TECHNICAL BULLETIN
LTB00625NAS1
28 APR 2014

'Knock' Sound From Front Suspension

Range Rover Sport (LW)

19. Check Pipes for Fouls

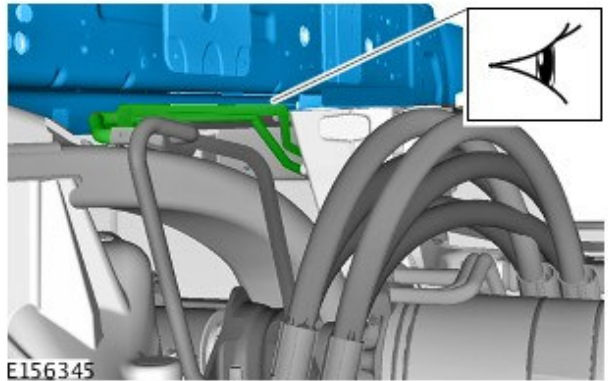
- Front pipe set to longitudinal. Check for a foul between the front hydraulic pipe set and the longitudinal.

20. Front Pipe Set to Subframe

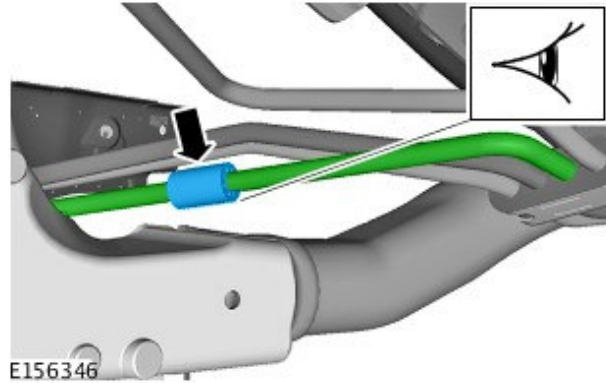
- Check that the rubber buffer is fitted to the hydraulic pipe. Ensure that there is not a hard foul between the hydraulic pipe and the sub frame.

21. Return Hose to Longitudinal

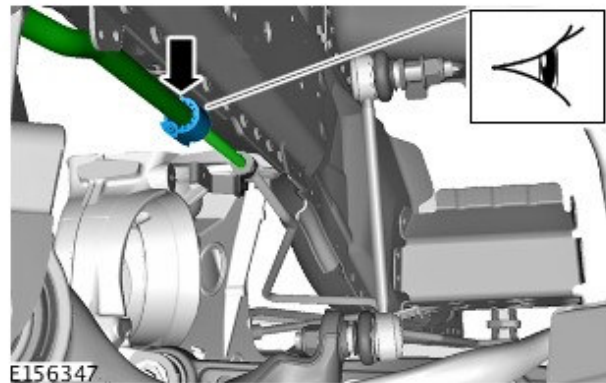
- Check that the rubber buffer is fitted and that there isn't a hard foul between the return pipe/hose and the underside of the longitudinal.

22. Rear Pipe to Aero Shield

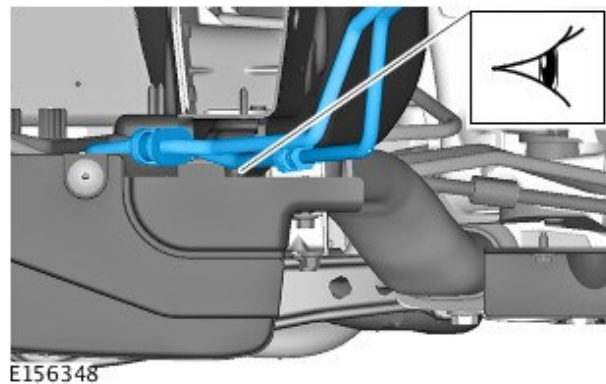
- Check for a foul as the rear pipes exit from the aero under shield.
- Check the hydraulic pipe routing under the aero shield and ensure free of fouls to the fuel pipes.

Valve Block to Body Stud Clearance

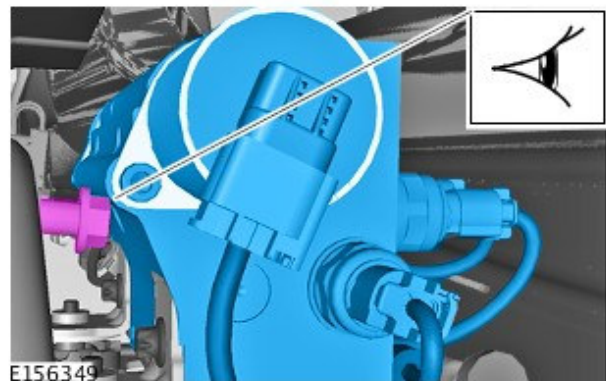
- There should be 5mm clearance between the valve block body and the plastic body fastener that secures the fuel lines. Where no or very little clearance exists, the head of the fastener should be modified, by removing it and drilling an axial hole 5mm diameter through the head, so that the body stud passes through the head of the fixing.

24. Front Pipes to Edge Clip on Subframe Ski Bracket (Front

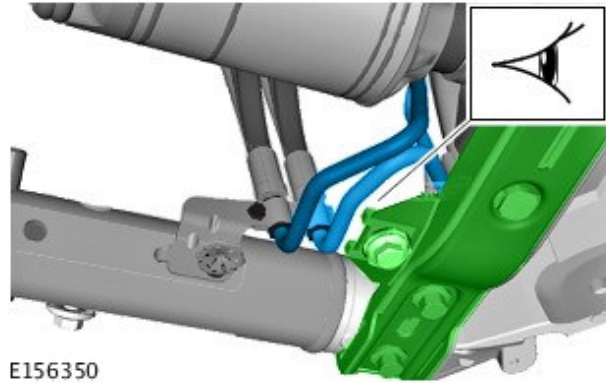
- There should not be a foul condition between the hydraulic pipes and the ski bracket.
- If a foul is present, adjust the hydraulic pipes until a clearance is achieved.

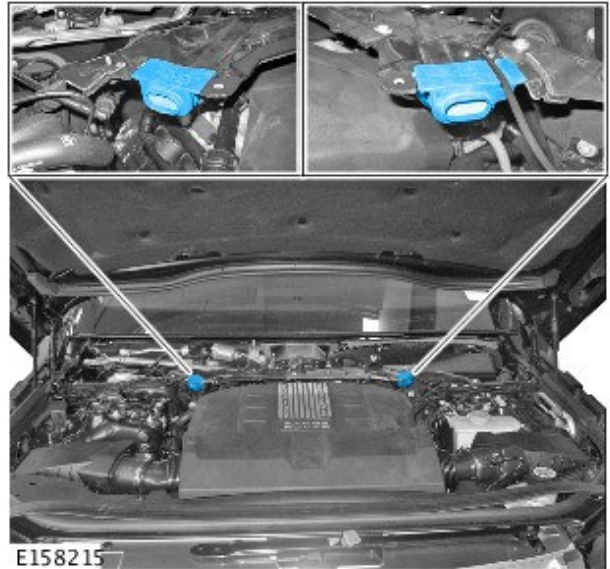
29.  **NOTE: one foam pad is sufficient for both strut brace bars.**

Insert foam pad (BTR6506; cut to a length of 38mm) into rear of each strut brace bar grommet as shown.

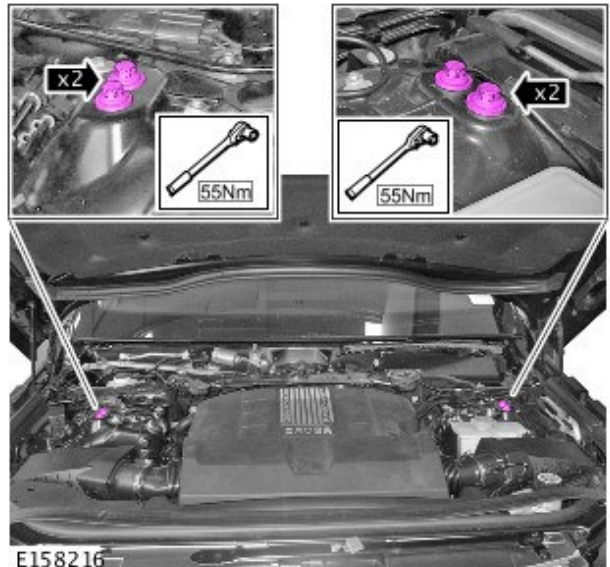
31.  **NOTE: discard the four (4) fixing bolts that attach the brace bar to the bulk head (below wind screen).**

Install strut brace bar bolts back into the struts as shown; tighten to 55Nm.
